ADDENDUM #2

BID NUMBER: ITB 006-024, TITLE: LIFT STATION PUMP REPLACEMENT

December 18, 2023

SECTIONAL ELEVATION

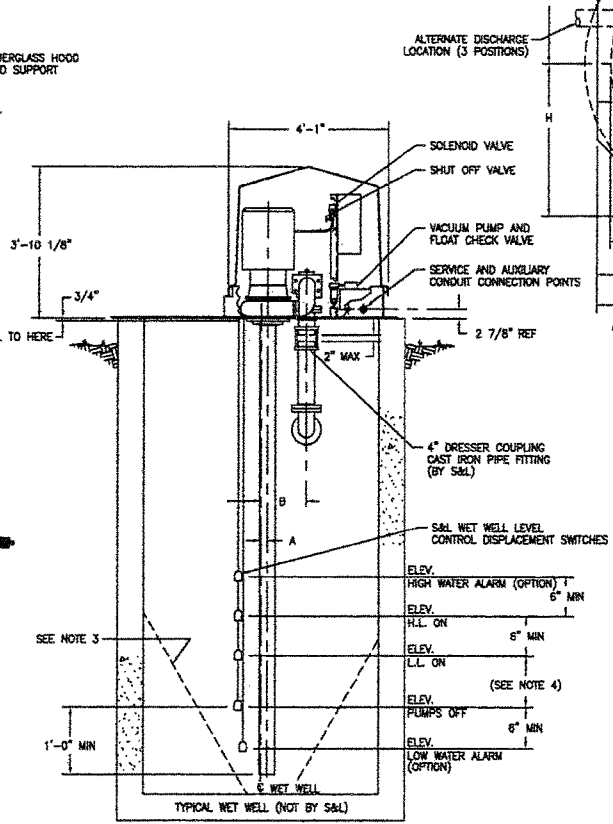
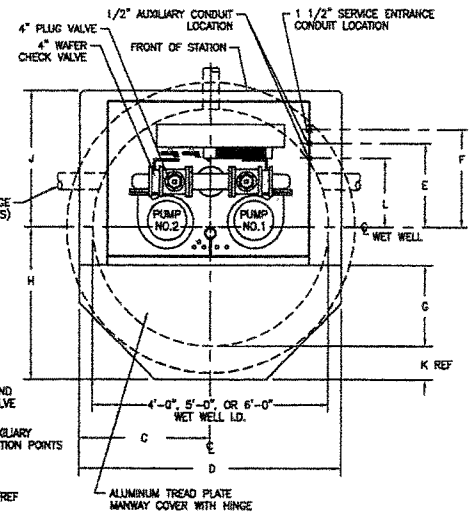
Q.1: Do we have dimensions of wet pit?

Q.2: Do we have elevations for any of the incoming/discharge pipe/wet pit bottom?

A: Only what is shown on the attached PDF files, but these do not match what was actually installed. Please field verify dimensions.

A: See attached PDF files, of the only existing drawings we have.

Sheet No.:
XC-2

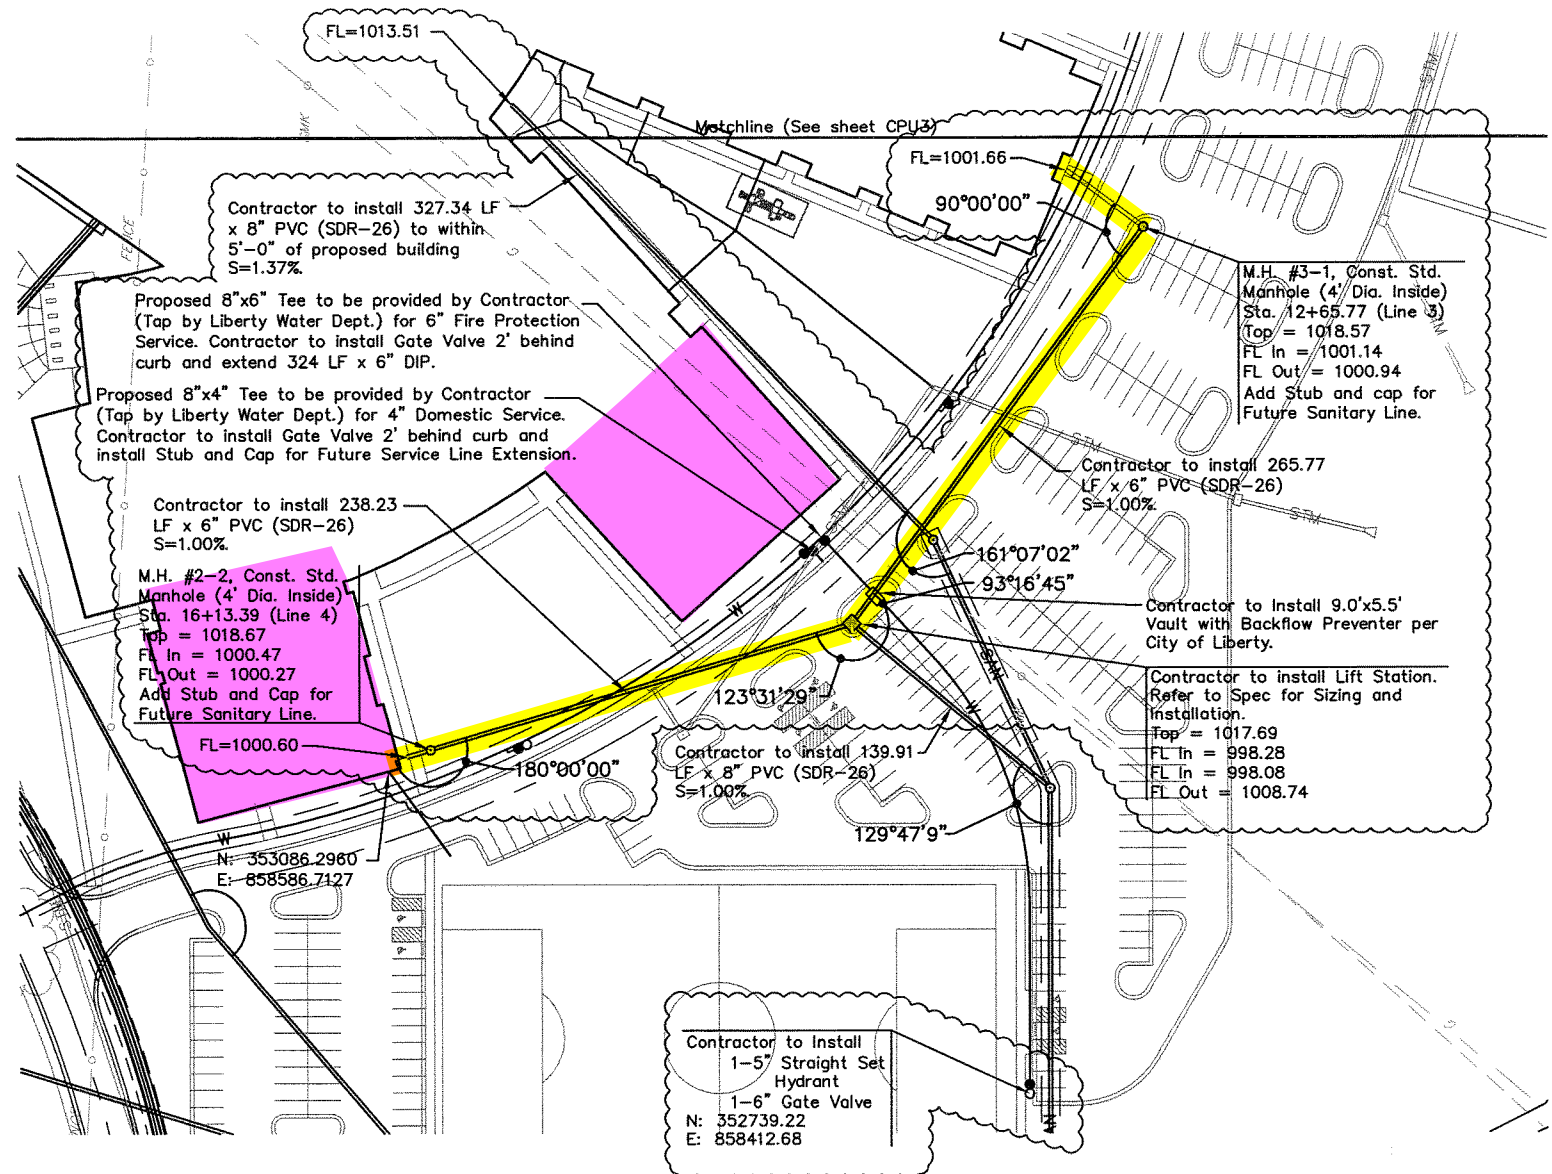
Q.3: Are there any original Plans?

A: See attached PDF files.
